# UNITED STATES PATENT AND TRADEMARK OFFICE

APPLICATION NO.	FILING DATE	FIRST NAMED INVENTOR	ATTORNEY DOCKET NO.	CONFIRMATION NO.
10/733,307	12/12/2003	Tsutomu Muraoka	SN-US025011A	7330

# Office Action Summary

# **ATTACHMENT**

【図8】

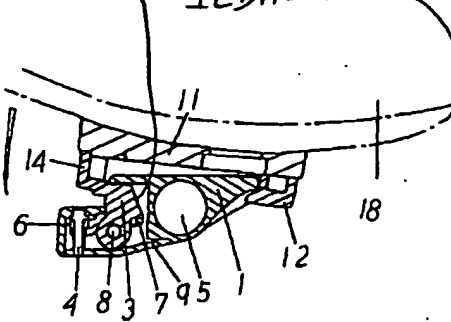
a cleat engagement mechanism 3, 2 coupled to an upper surface of said pedal body 1, q, said cleat engagement mechanism 3, 2 including a front clamping member 2 (Fig. 7) coupled to said front end of said pedal body 1, q, and a rear clamping member 3 (Figs. 8 and 9) movably coupled to said rear end of said pedal body 1, q,

said rear clamping member 3 including a forwardly facing rear pedal control surface (Att.), said forwardly facing rear pedal control surface inherently being a transfer surface.

Note that Date's forwardly facing rear pedal control surface inherently transfer, e.g., the heat or force. Therefore, Date's forwardly facing rear pedal control surface reads on Applicants' claimed transfer surface.

Applicants' claim 32 broadly recites "a transfer surface" without any mention about force. Meanwhile, the surface pointed to in the attachment does transfer, *e.g.*, heat from the outside atmosphere to the body of the clamp 3. Thus, the surface pointed to in the attachment "reads on" the claimed "transfer surface." *Kalman v. Kimberly Clark Corp.*, 218 USPQ 781, 789 (CAFC 1983).

On the other hand, the surface pointed to in the attachment *does* transfer a force from the cleat. In fact, as shown in, *e.g.*, Date's Figs. 7-10, when the rider applies or pushes the cleat 11 into engagement with the clamp 3, a force exerted by the rider's foot is transferred from the cleat 11 to the clamp 3 via its hook 14. The instant force causes the clamp 3 moving forwardly toward the body 1 of the pedal as best seen in Figs. 9 and 14. The movement of the clamp 3 is stopped when the clamp 3 is abutted with the body 1 of the pedal. At the time that the clamp 3 is abutted with the body 1 of the pedal, the force is then transferred from the clamp 3 to the body 1 by the surface pointed to in the Attachment. Therefore, claim 32 is again "fully met" by Date.

【図10】

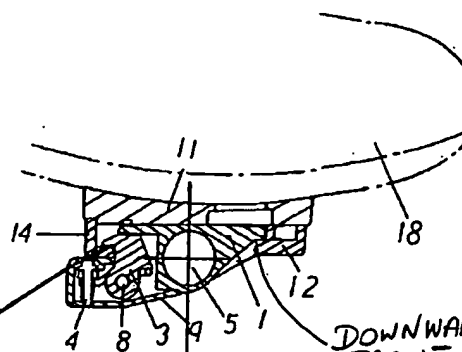
Regarding claim 33, said front and rear cleat engagement surfaces (Att.) are *substantially* parallel as seen in, e.g., Figs. 2 and 10.

Regarding claim 31, said front clamping member 2 includes a downwardly facing front cleat engagement surface (Att.) disposed in a first plane (Att.), and said rear clamping member 3 includes a downwardly facing rear cleat engagement surface (Att.) disposed in a second plane (Att.) that is offset from said first plane (Att.) of said front cleat engagement surface 2 as best seen in Figs. 2 and 10.

Date's first plane (Fig. 10 of Att.) of the front cleat engagement surface 2 is farther to the center rotation axis (Att.) than the second plane (Att.) of the rear cleat engagement surface (Att.) as measured in a direction perpendicular to the first and second planes (Att.).

It is common knowledge in the art to reverse or rearrange Date's first plane of the front cleat engagement surface such that it is closer to the center rotation axis than the second plane of the rear cleat engagement surface as measured in a direction perpendicular to the first and second planes in order to couple Date's cleat to Date's pedal. To rearrange Date's first plane such that it is closer or farther to the center rotation axis than Date's second plane would have been an obvious choice in design because the claimed structure and the function it performs are the same as the prior art. *In re Chu*, 66 F.3d 292, 36 USPQ2d 1089 (Fed. Cir. 1995). See also legal precedents regarding rearrangement of parts in MPEP 2144.04. Moreover, the first plane of the front cleat engagement surface which is closer to the center rotation axis than the second plane of the rear cleat engagement surface as measured in a direction perpendicular to the first and second

It would have been obvious to one having ordinary skill in the art at the time the invention was made to rearrange Date's first plane such that it is closer instead of being farther to the center rotation axis than Date's second plane in order to couple the cleat to the pedal as taught or suggested by common knowledge in the art.
